NISSAN DIESEL AMERICA, INC.

TECHNICAL BULLETIN GE-34

PRE-HEATER RELAY RESISTANCE CORRECTION

AIR INTAKE PREHEATER RELAY

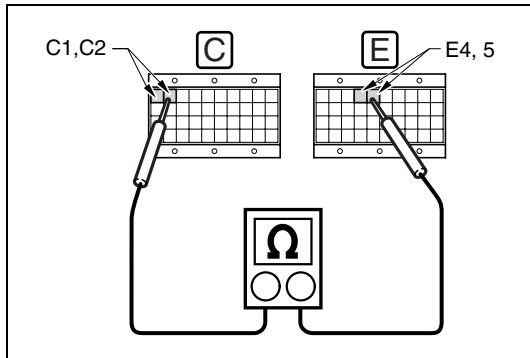
The 2005 & 2006 UD Trucks Service Manual CD's have incorrectly listed the resistance values for the pre-heater relay (glow plug relay) for the J05 and J08 engines. The relay illustration for the J05 is also incorrect.

The pre-heater relay should have the following correct resistance values in the diagnostic flow charts:

- Step 1 - 4.5Ω to 9.5Ω
Step 2 - 6.0Ω to 7.6Ω

Standard: 4.5 — 9.5 Ω

2. CHECK THE RESISTANCE OF PREHEATER RELAY.

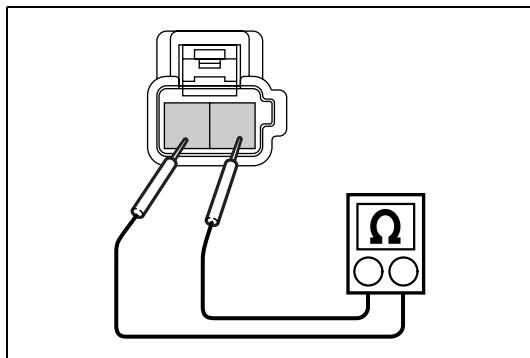
The illustration of the relay on DN02-65 for (J05) is also incorrect. The illustration should be the same as the illustration found on page DN02-66 (J08).

Standard: 6.0 — 7.6 Ω
